PROJECT NAME: A New Building for: Dalton Police Department  
For The City of Dalton, GA

PROJECT NUMBER: 23-021

FROM: KRH Architects  
855 Abutment Road  
Suite 4  
Dalton, GA 30721

**Item No. 1****Prebid Sign In Sheet**

**P3.1**

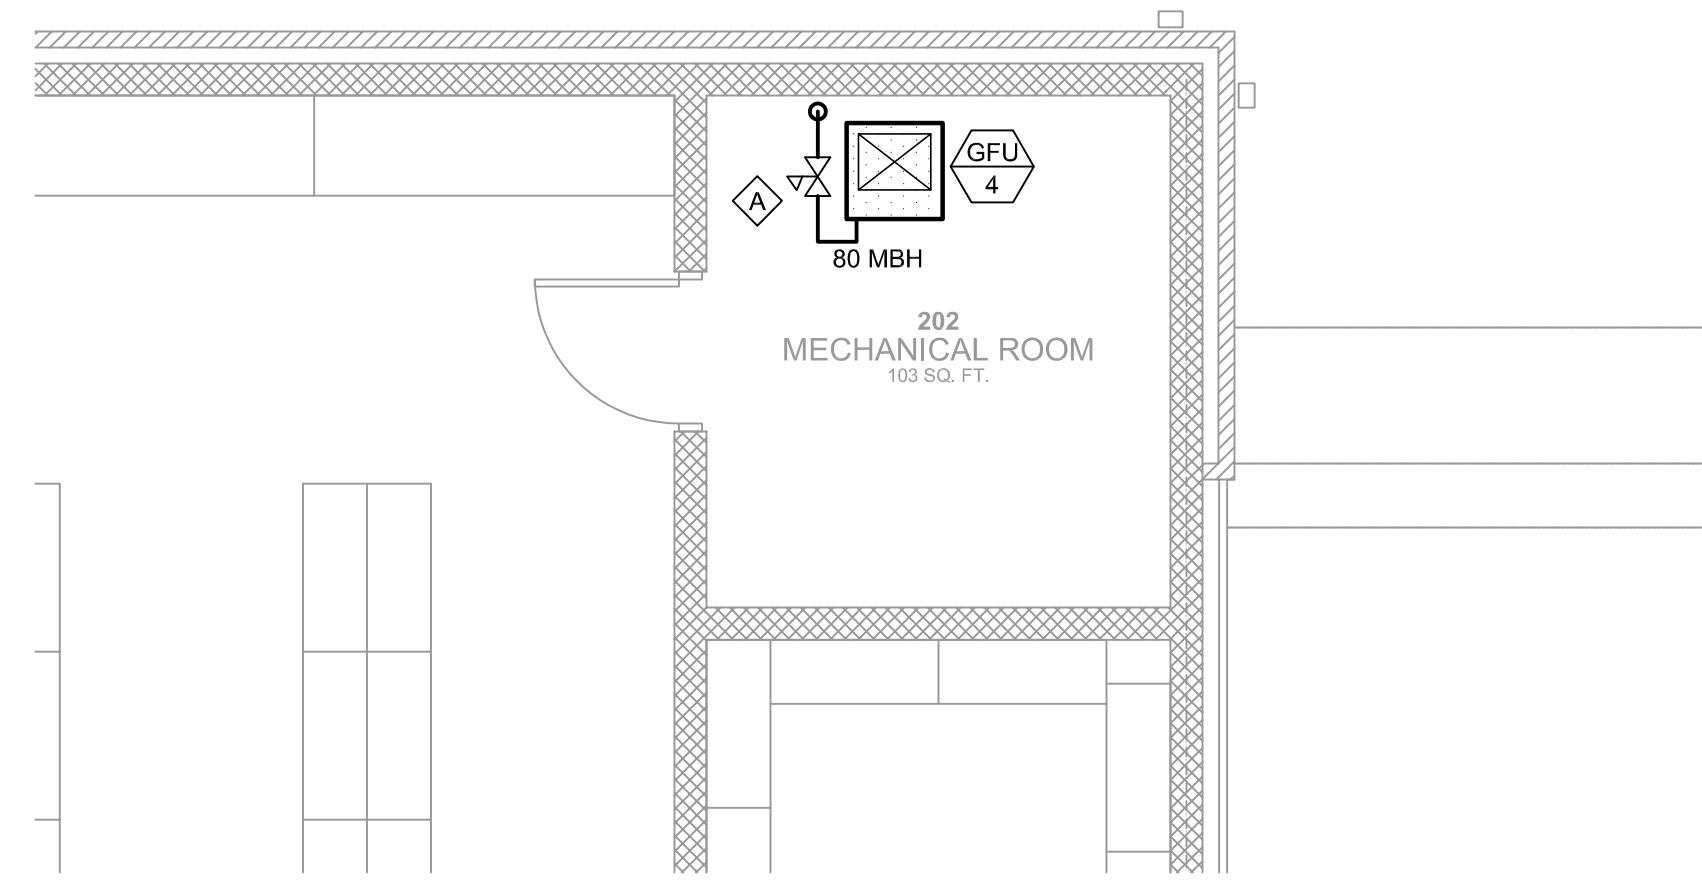
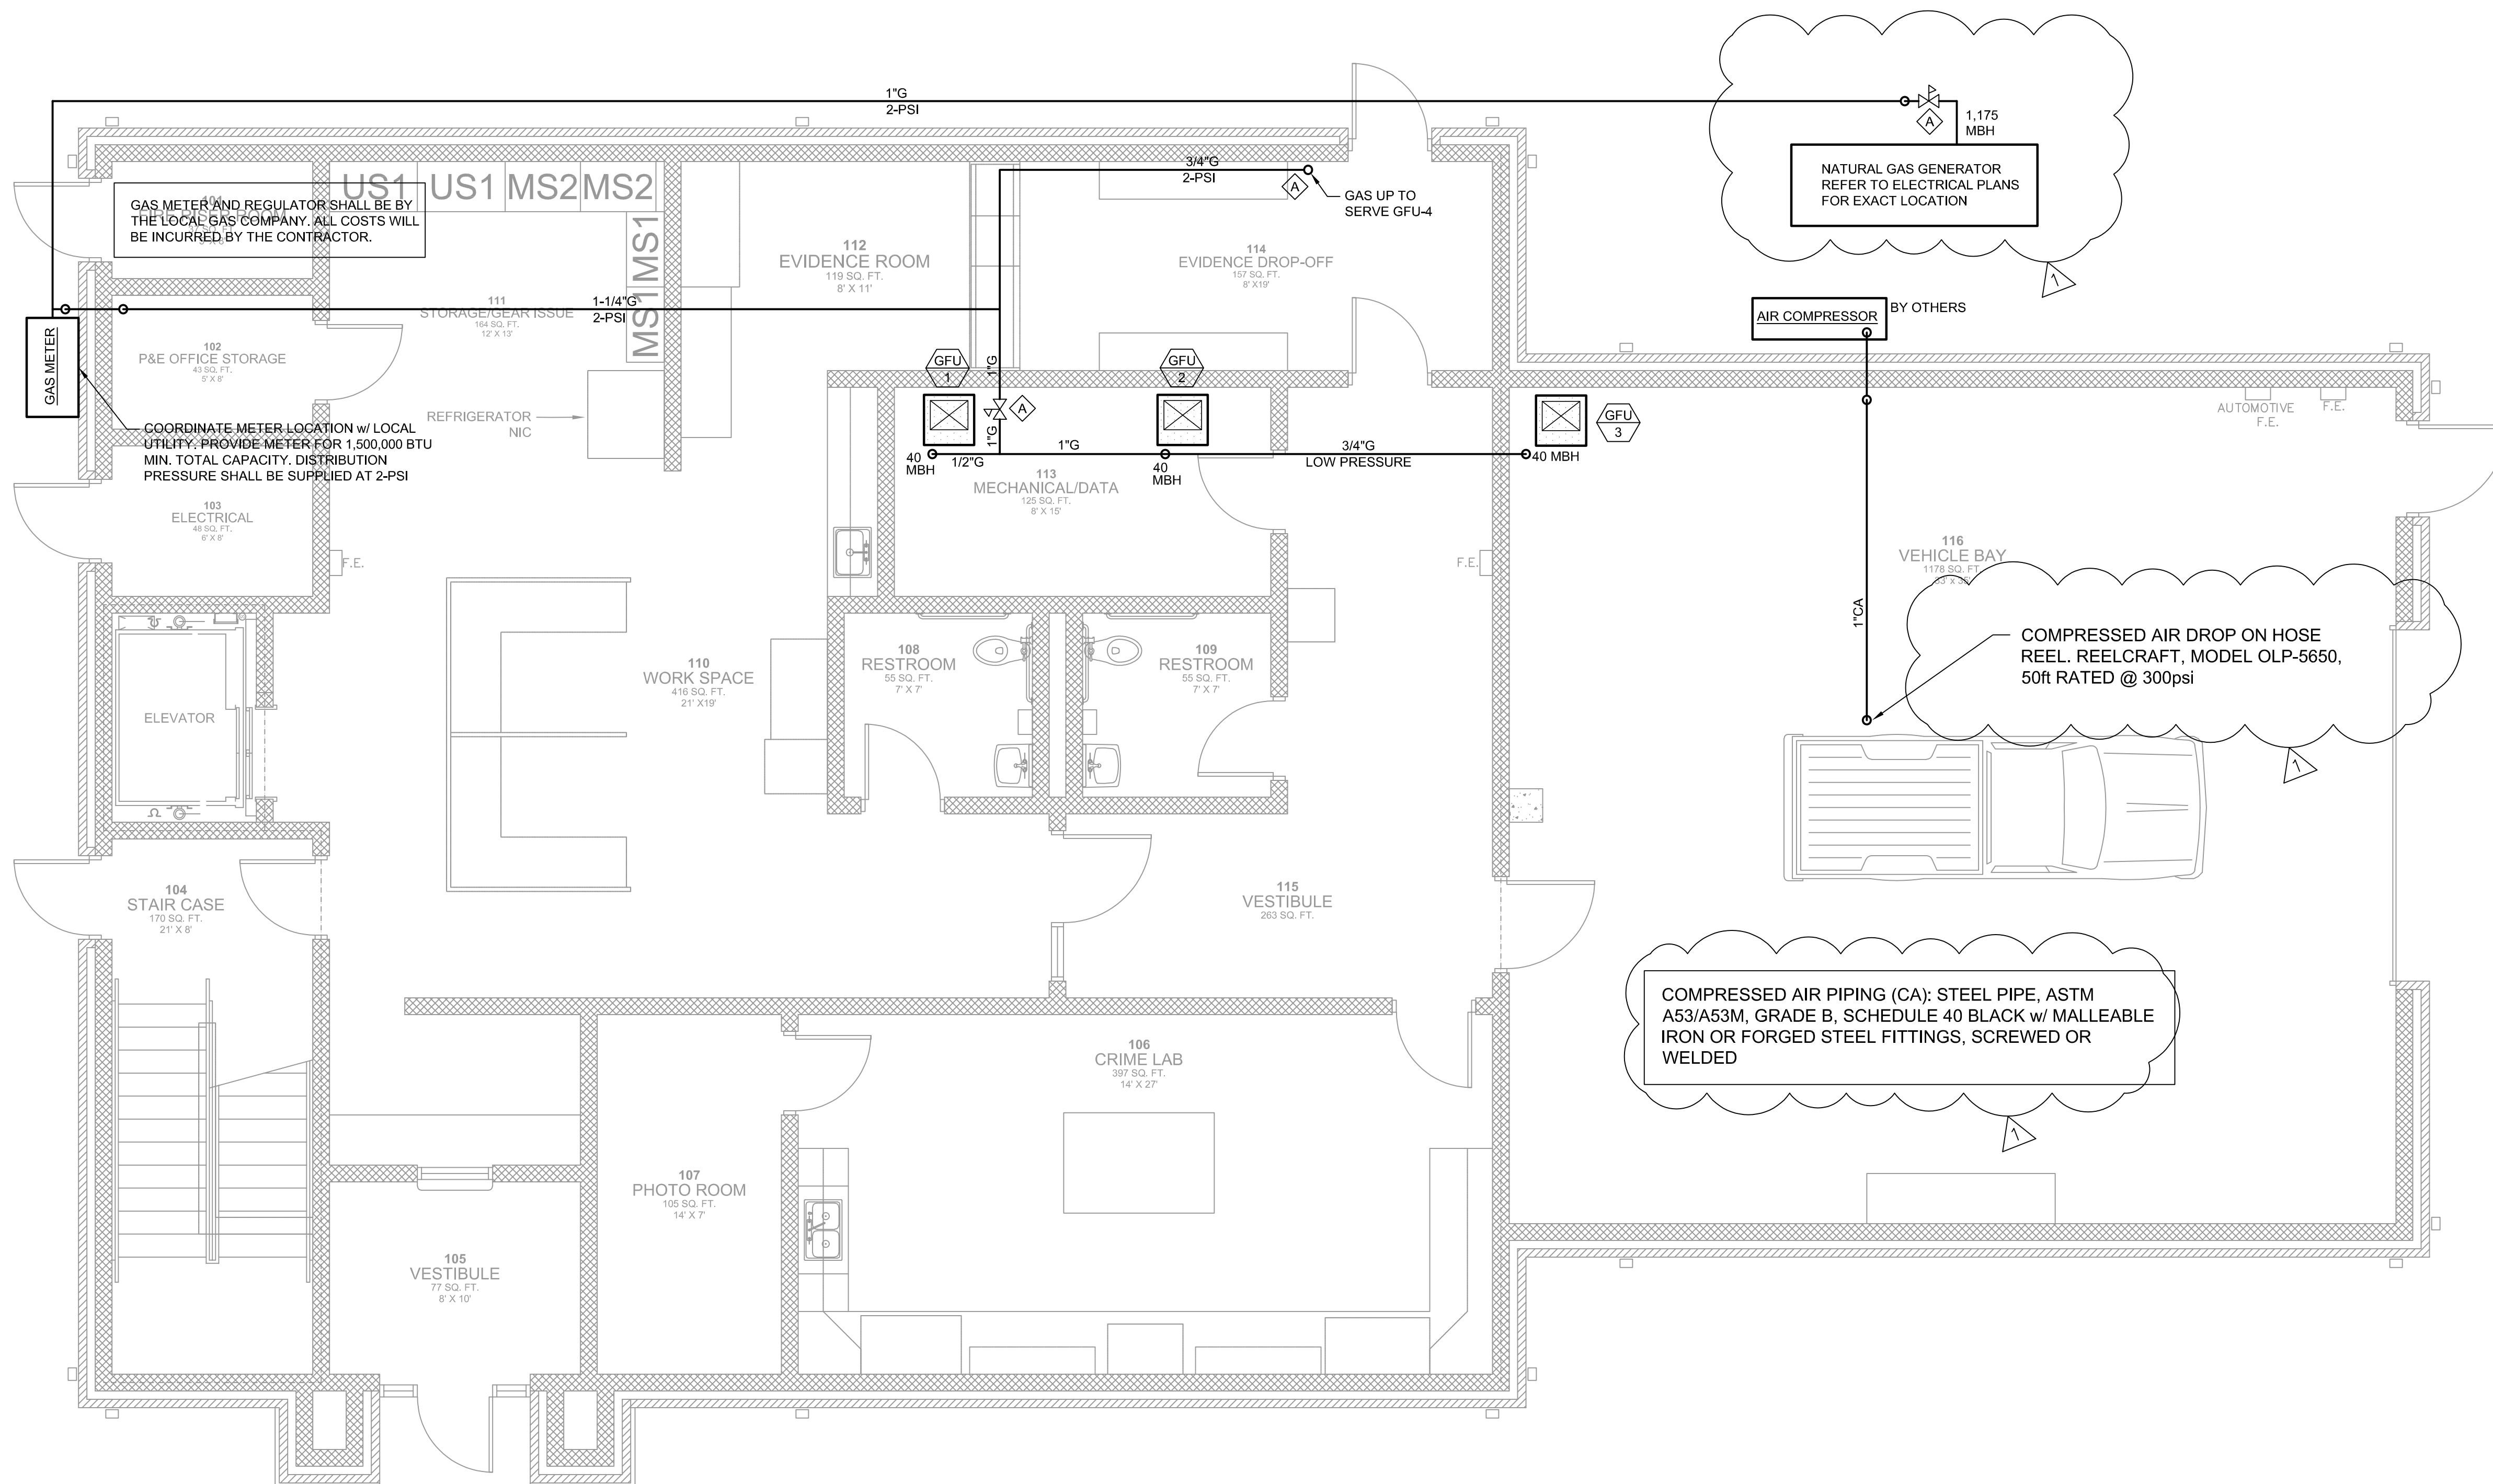
4. Drawing P3.1 shows a compressed air line running overhead in the vehicle bay. What is the spec for the air piping? **Answer: Compressed Air Piping (CA): Steel Pipe: ASTM A53/A53M, Grade B, Schedule 40 Black with malleable iron or forged steel fittings, screwed or welded.**
